**Issue: Older Ford engines with centrifugal oil filters need a head with an oil feed hole, but newer heads are not drilled for it.**

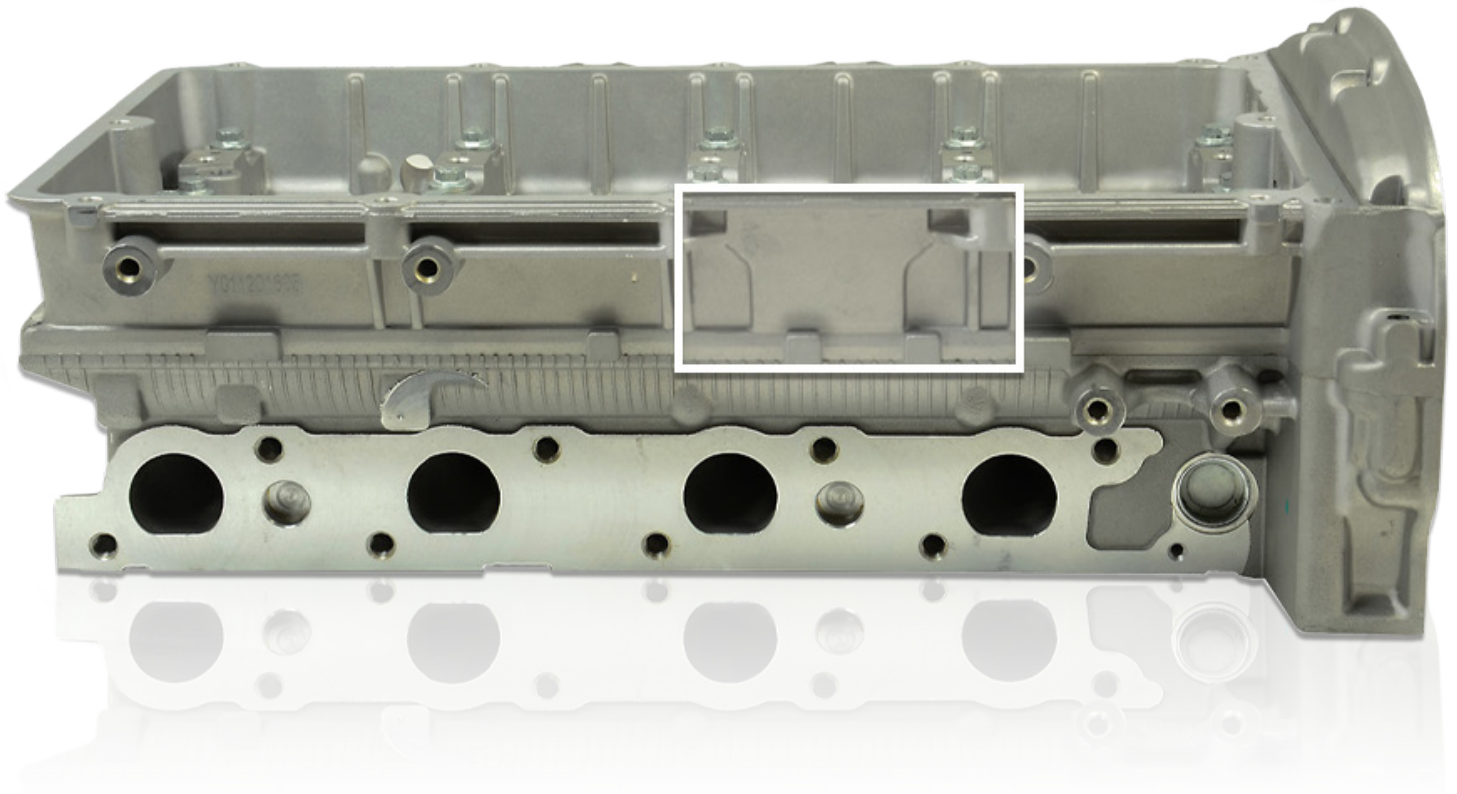
Older Ford heads had a hole in the area shown in the circle below, which was needed for the oil feed to the centrifugal oil filter. Ford eventually stopped production of the filter so the hole was no longer needed.

If your engine has the old centrifugal system, you can use the FAI **BCH020** cylinder head. If using this, you will need to remove the oil pipe from the block and seal the hole in the block using the Ford plug, Finis No. 1512462.
